Response to RFI Item Number 4.1
Coole Wind Farm

Coole Wind Farm Ltd.

September 2022

Figure 2-1 Plan of ground investigation at T12 with recorded peat depths shown

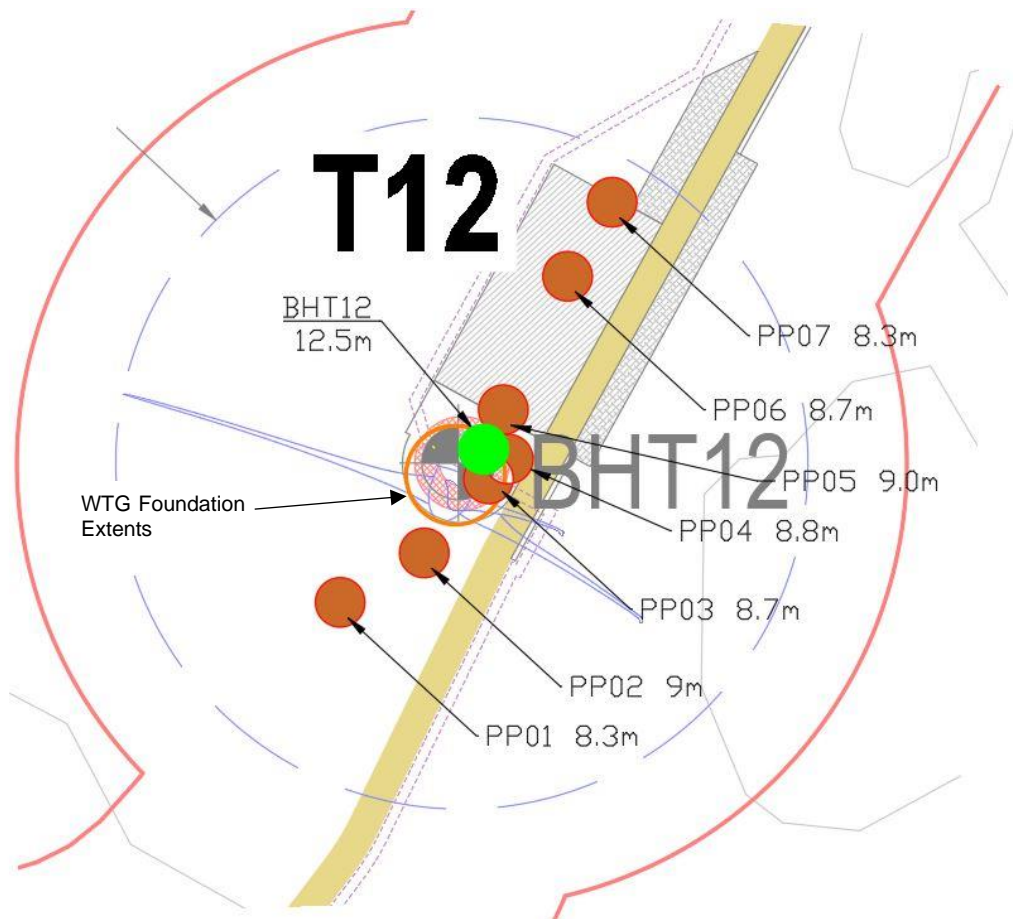
“4.1 In section 8.3.2.1 of the EIAR it is stated that the recorded peat depth at T12 is given as 12.5m - from the 2020 rotary core boreholes while the peat depth within 50m is 4.5m based on table 8-4. You are requested to justify the location of the turbine in very deep peat and at a location where the slope angle is 3 degrees and to consider whether there is a more suitable alternative.”

- The rotary core borehole at T12 identified a peat depth of 12.5m
- The peat probes identified a peat depth of 8.7m at the closest probe to the centre of the turbine foundation and a maximum of 9.0m in the vicinity of the turbine and hardstand.

A variety of peat depths have been provided from various techniques. The peat depth affects peat stability calculations which are used as part of the justification of turbine positions. Therefore, selection of an appropriate and representative peat depth is important. From experience, the peat probes provide the most reliable representation of the peat depth at T12 for the reasons detailed below.

- The Rotary Core Borehole at T12 overestimates the depth of peat (the borehole log suggests a peat depth of 12.5m).
- The peat probes completed to inform this RFI response suggest the peat depth to be 8.7m at the centre of T12 and a maximum peat depth of 9m in the vicinity of the turbine and hardstand.
- The rotary coring technique used at T12 is not suitable for accurately determining the interface between two soft materials such as peat and clay and was used to identify the depth to a solid stratum (Limestone) at Coole.
- The depths provided by the peat probes are considered to provide the most accurate peat depths and should be used for assessment purposes.
